## **Better Market Street Project EIR APPENDIX 1: SCOPING REPORT**

PLANNING DEPARTMENT  
CASE NO. 2014.0012E

**BETTER MARKET STREET  
ENVIRONMENTAL IMPACT REPORT (EIR)  
SCOPING REPORT**

May 22, 2018

Exhibit A - Site plan; excerpt of survey

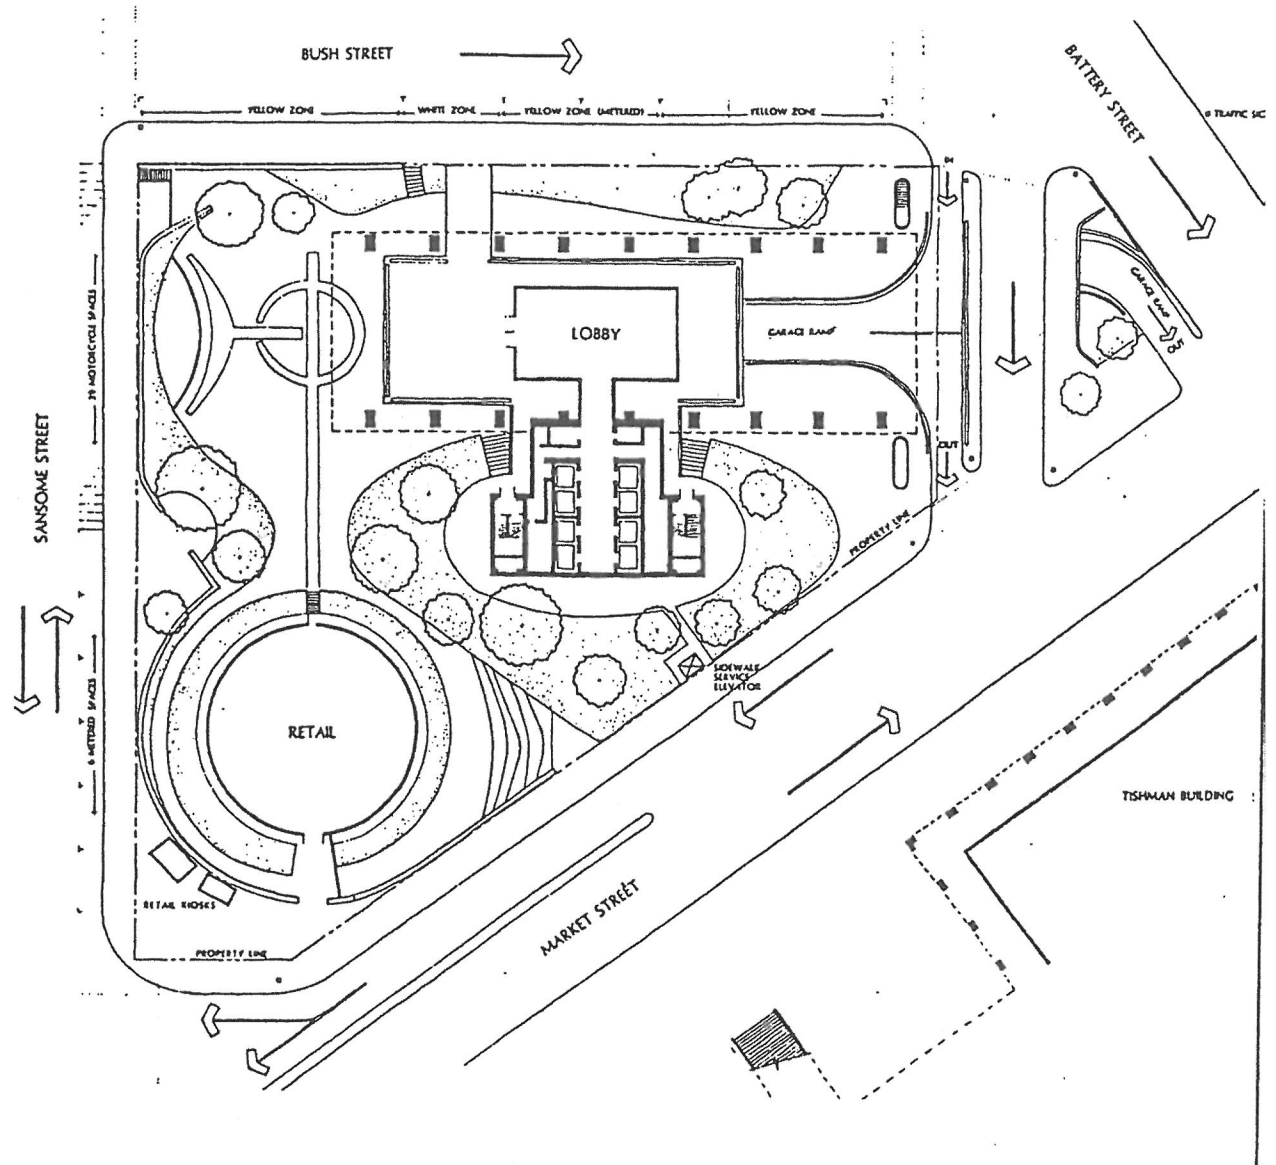
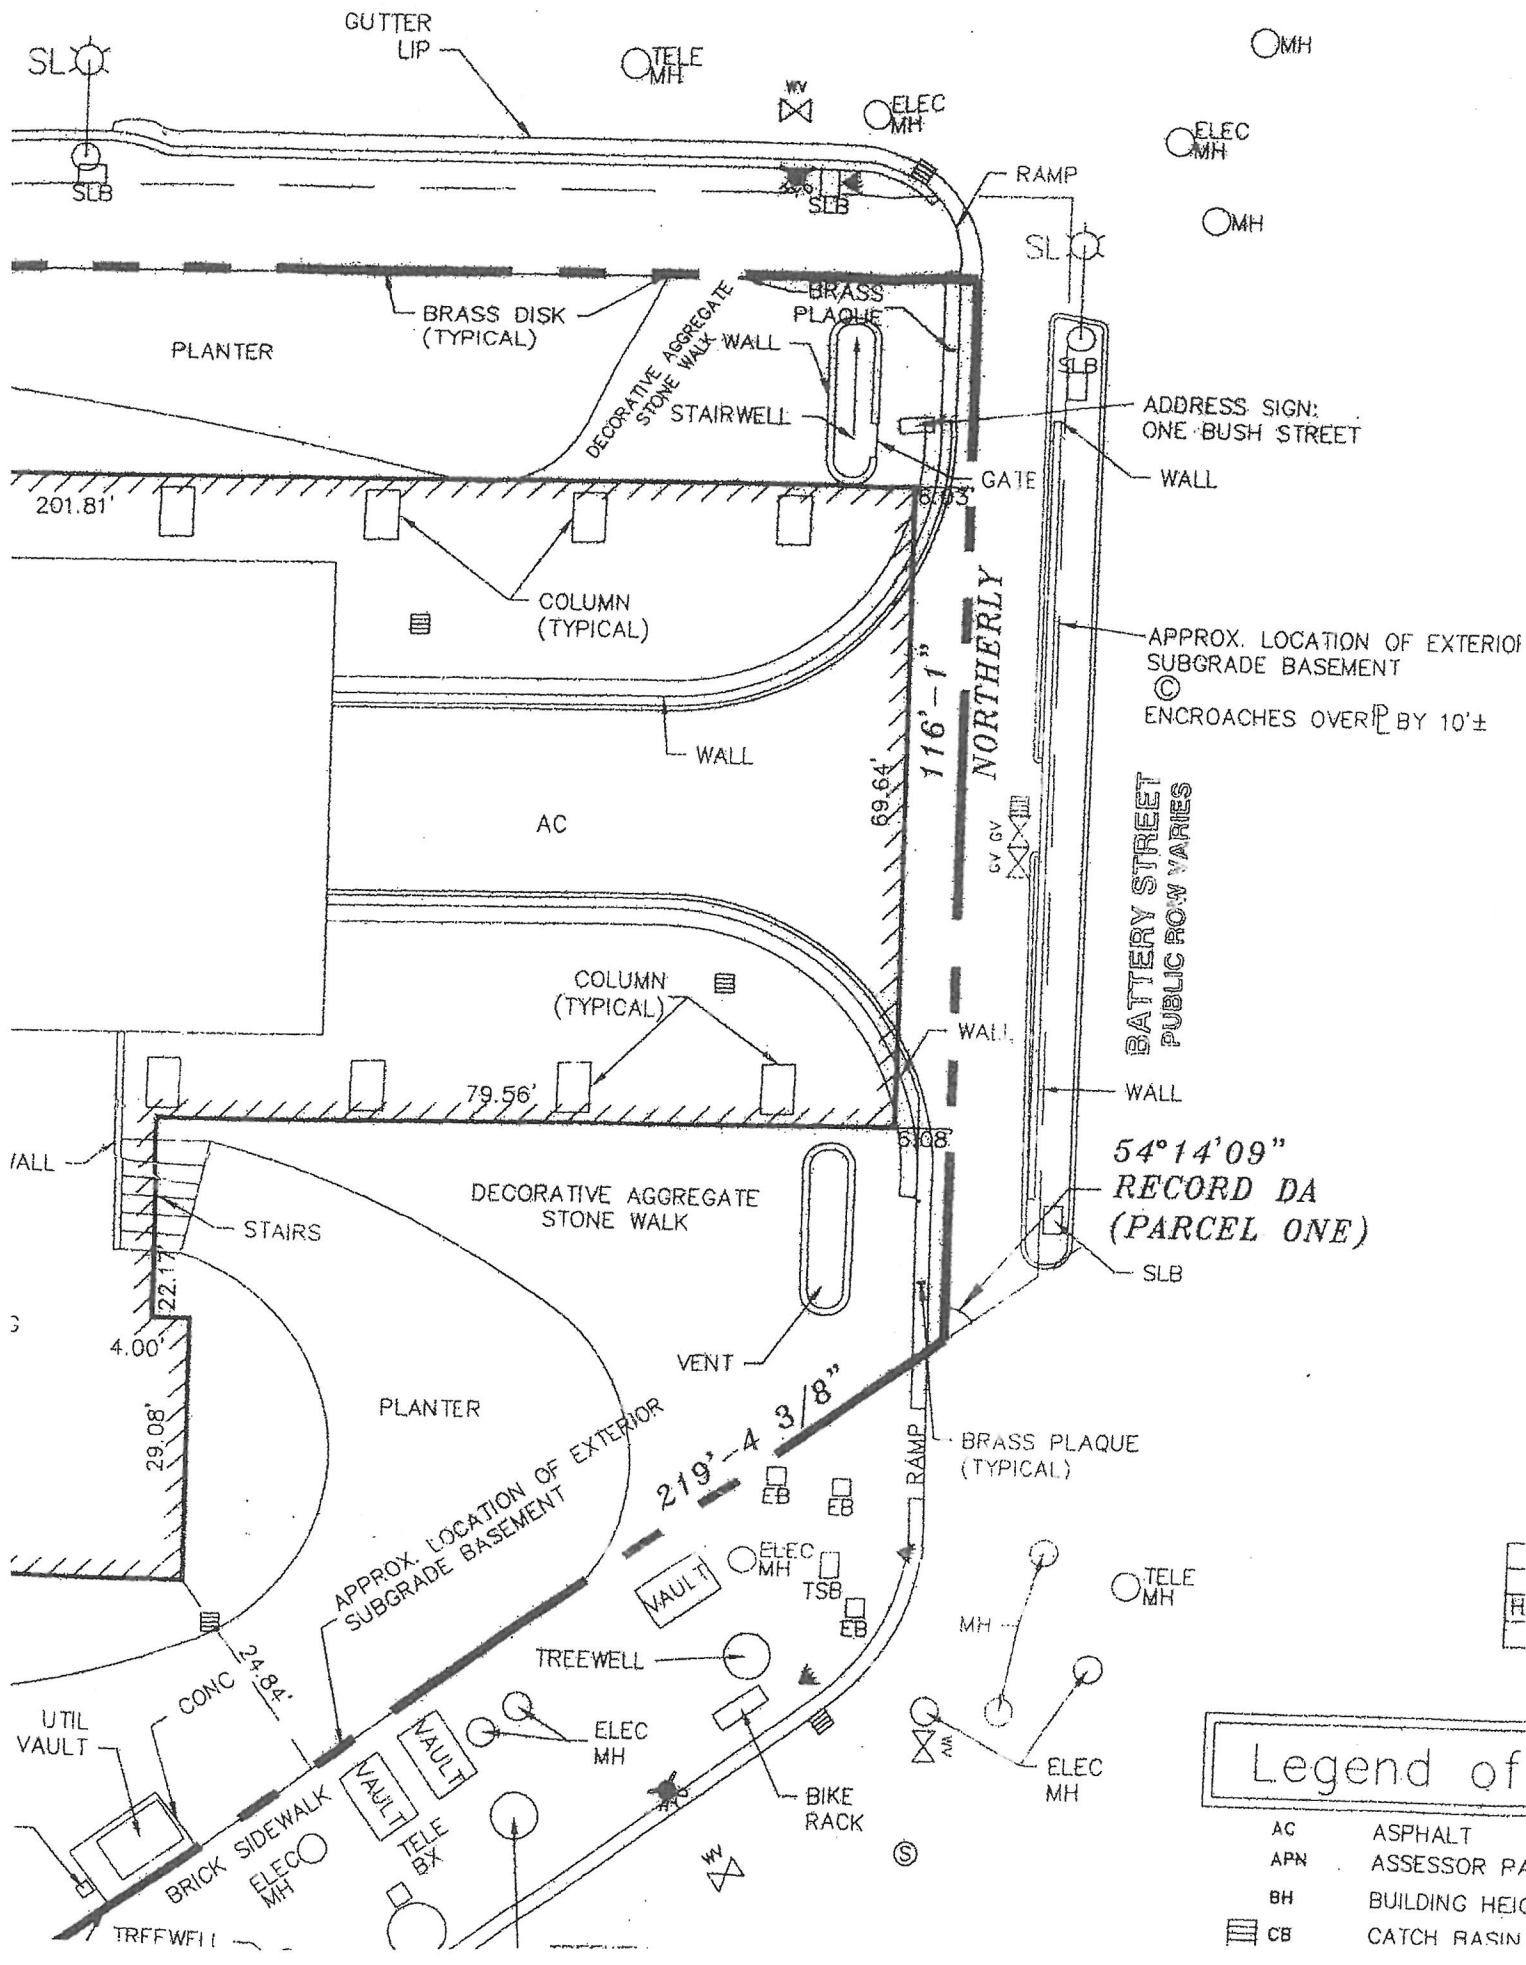
We respectfully request, that the proposed Plan, and specifically Alternatives 1 and 3 therein, be amended with respect to private vehicle access by including an exception that would allow private vehicle access onto Market Street from the existing garage at One Bush for a distance of approx. 270 feet until Sutter Street. The overall situation and the need for such an exception are unique to One Bush, which is a Landmark site and one of the few or only sites with an existing exit onto Market Street. As a Landmark site, the garage from One Bush cannot easily be reconstructed to provide for a functional alternative to the existing vehicular exit onto Market Street without causing a significant impact on the publicly accessible open space plaza.

As outlined in this letter, the impacts caused by the implementation of the Plan on One Bush are extreme and negative however, the "expense" of providing the requested exception is very minimal. An exception is requested only for the length of approx. 270 feet on Market Street for a short distance that is not currently occupied by any cross-walks. Given the timing of the traffic lights, vehicles from One Bush could exit onto Market Street only when permitted transit and other vehicles are stopped at the First and Market traffic light for the crossing of traffic from Battery/Bush onto First Street. Please note that the existing lights are already timed this way so that it is possible to exit One Bush on a green light only when the light along Market
